WORKPLAN FOR CONDUCTING SOIL BORINGS

TRUCKER'S FRIEND
1395 7th Street
Oakland, CA 94607

Submitted By:
BERNABE & BRINKER, INC.
2240 Wood Street
Oakland, CA 94606
(510) 451-3482

Prepared by:
Mark R. Varney
May 26, 1997

FIGURE 2.

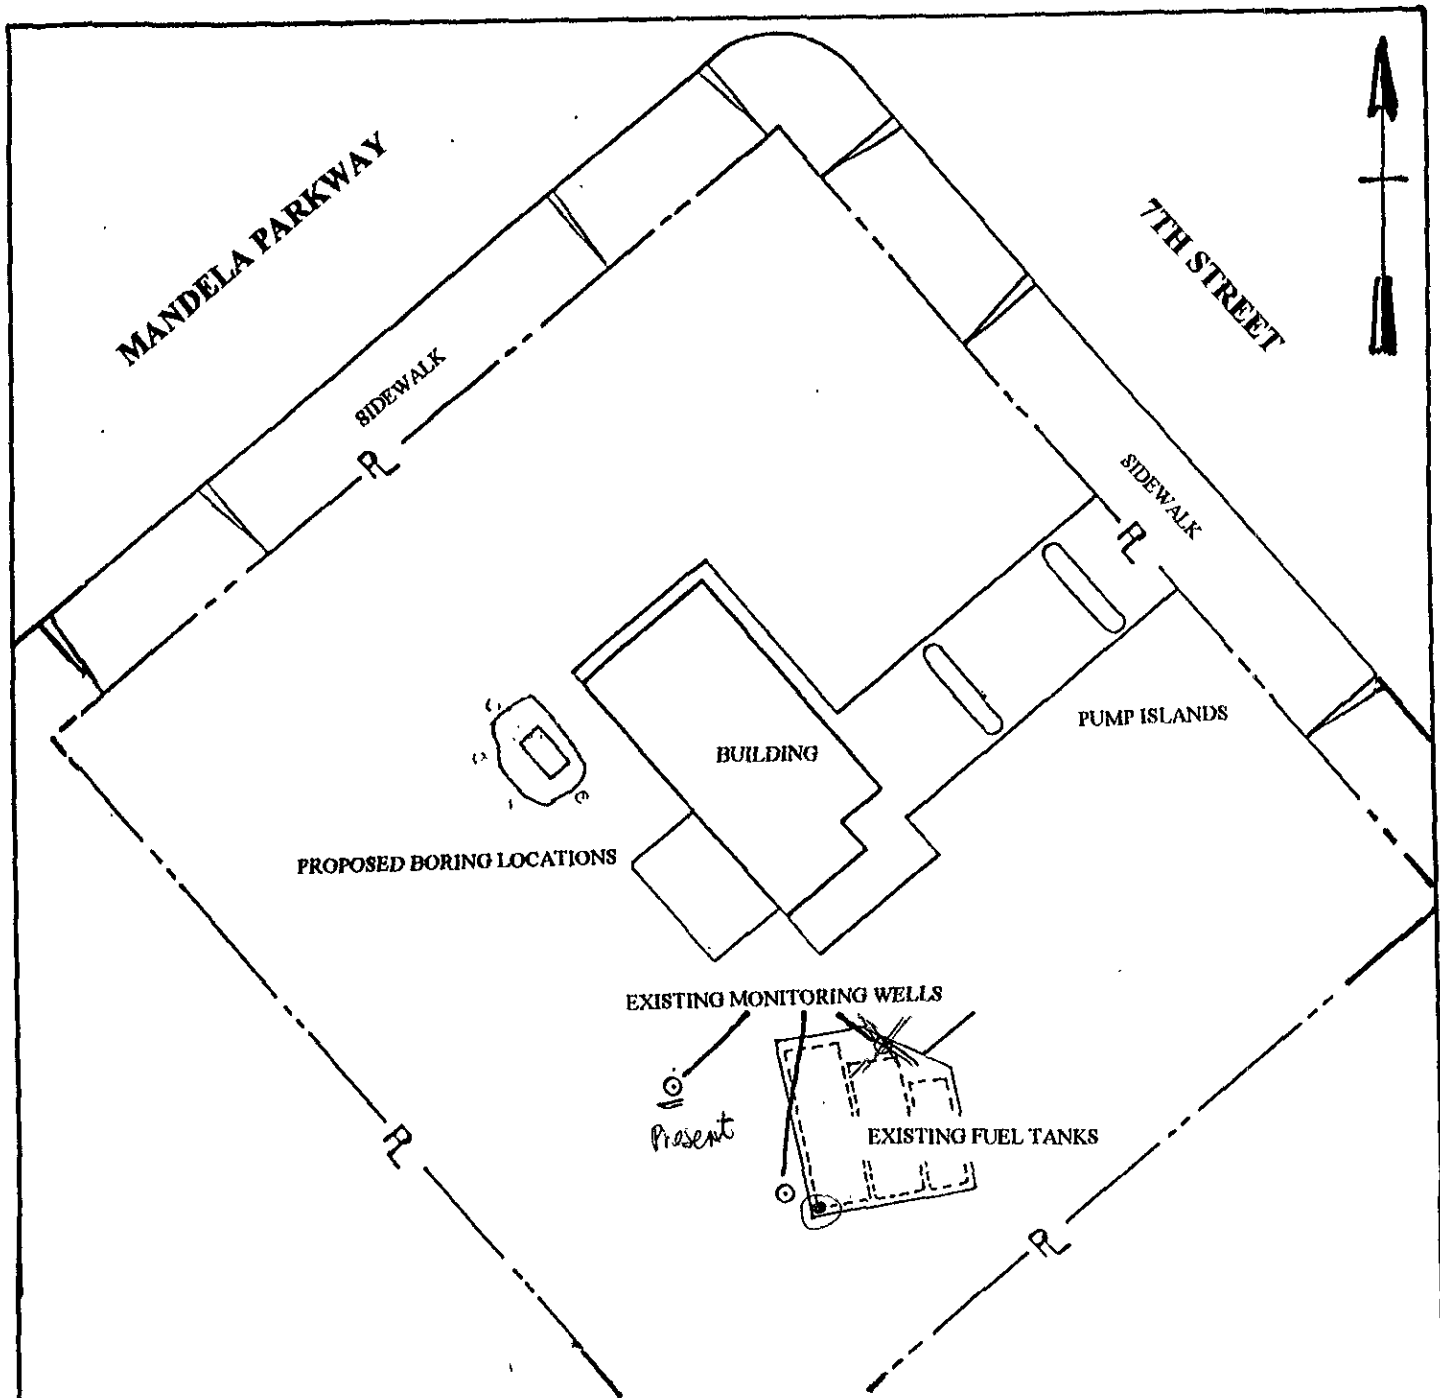
The soil boring locations are based on groundwater flow direction and gradient data obtained from monitoring wells located onsite. Data gathered from quarterly groundwater monitoring reports indicate that groundwater flows to the southwest. The location of the proposed soil borings are shown in Figure 2. *ok*

The proposed soil borings will be located within 10 feet and in the downgradient direction of the overexcavated area in accordance with the California Regional Water Quality Control Board's "Tri-Regional Board Staff Recommendations for Preliminary Evaluation and Investigation of Underground Tank Sites," dated August 10, 1990. Additionally, one of the borings will be drilled near the location of overexcavation sample (SA-4). *not shown*
